Access Compliance Report Public Rights-of-Way (Pedestrian Signals)

Main Street: **NEWLAND_ST** Cross Street: **HAZARD_AVE** Location: **NE**

ADA ID: **SGRK210929115803** Signal Type: **One Push Button-Non APS** Overall Compliance: **No** Severity Scores: **BTN 1: 35** **BTN 2: N/A** **No BTN: N/A**

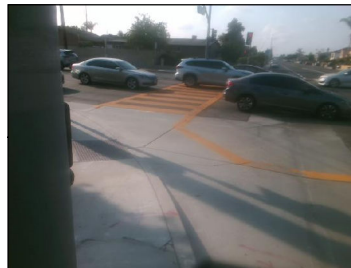
OC Std/PROW: **R404.2, R404.3, MUTCD 4e.08**

Possible Solutions: Replace Signal Push Button With APS Button. Remove and Replace Clear Space.
